Remarks From RadCon

Mikhail Kostin

Wednesday, December 9, 2020

Be Target Assembly (Preliminary Results)

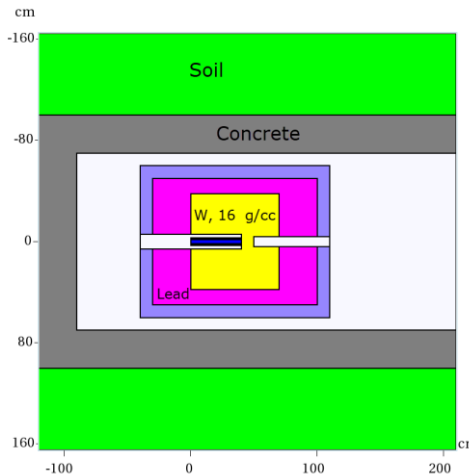
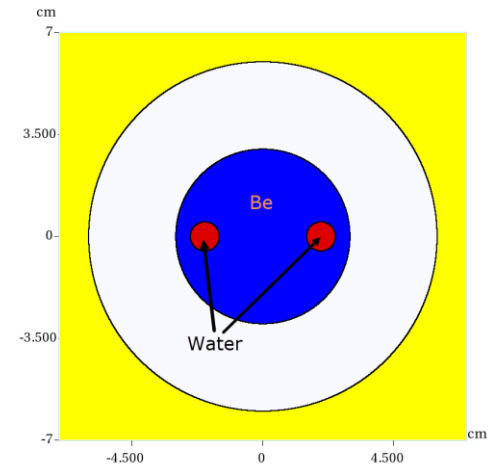
- Calculation for energy deposition, prompt dose and residual activation of one of Be target assemblies
 - Cylindrical symmetry
 - Added cooling water channels in Be
 - Approximate calculations – currently no access to MCNP data libraries for low energy neutrons (export controlled)

- Photon source
 - 10% Cu (0.14 cm) radiator instead of full CPS
 - 67 m upstream
 - 2 cm diameter on Be face
 - Originated from 12 GeV electron beam, 60 kW

Be Target Assembly (Preliminary Results)

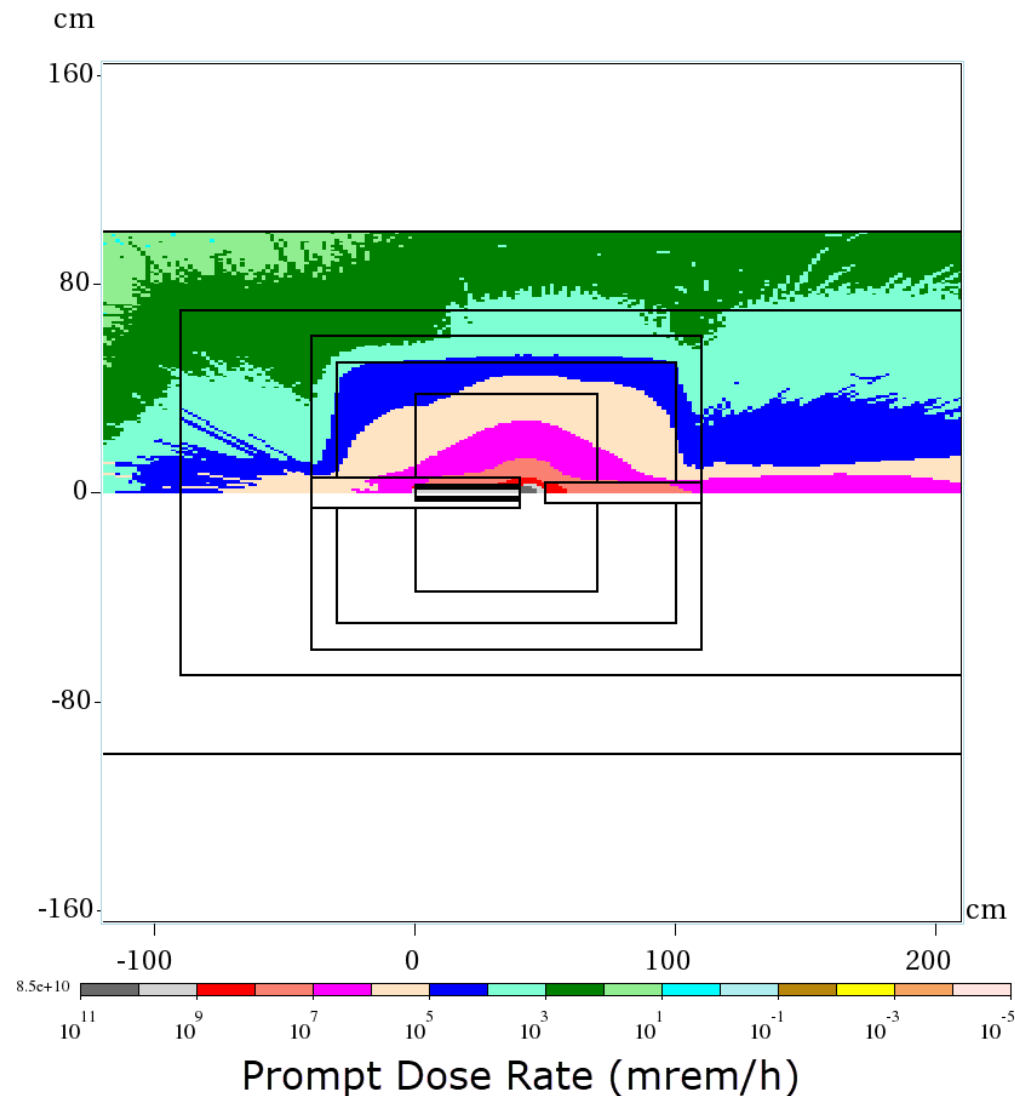
- Prompt Dose above
 - Higher than 1,000 mrem/h at ceiling
 - Approximately 3 m or so of shielding above alcove
 - Rule of thumb: 1 m of concrete or soil provide a factor of ~ 10 in dose reduction
- Expect >1 mrem/h above ground
- Too high to be comfortable – will need more accurate model

Be Target Assembly (Preliminary Results)

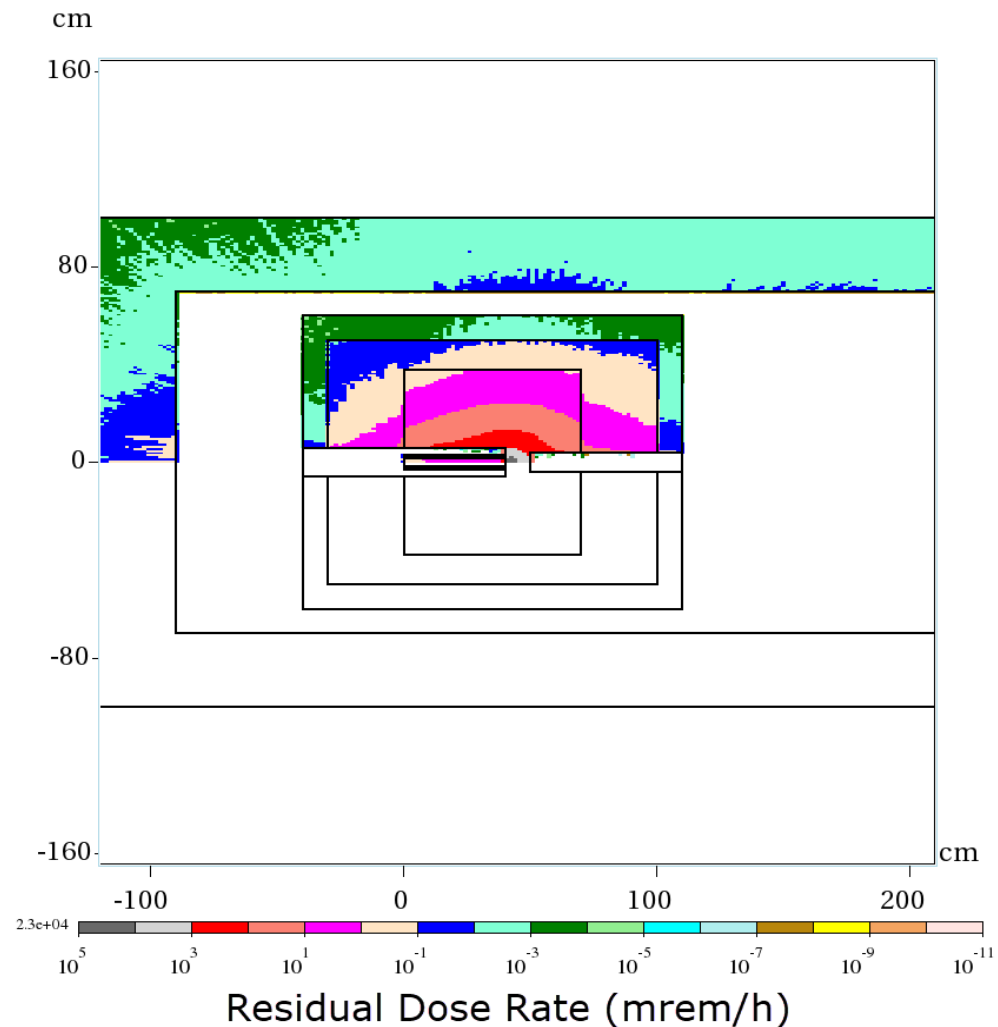
- Residual activation
- Dose on contact, 1 year of irradiation, 1 day of cooling
- Up to 0.1-1 mrem/h on lead surface
- Borated polyethylene is probably too thin (10 cm), may not be able to effectively shield components inside
- Residual dose is manageable

Be Target Assembly (Preliminary Results)

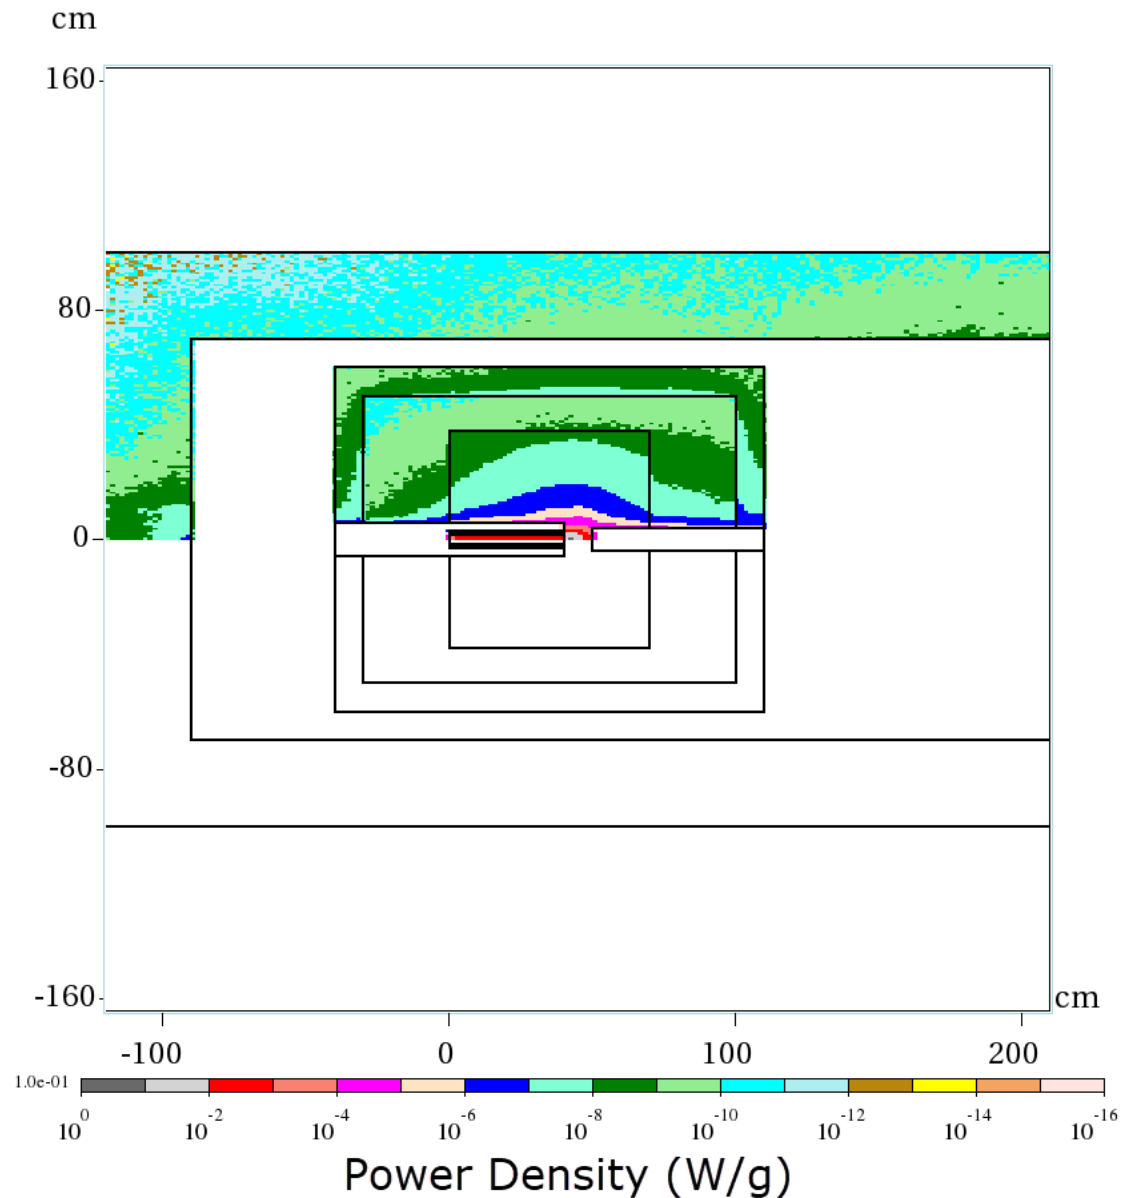
- Deposited power density (need to check normalization)
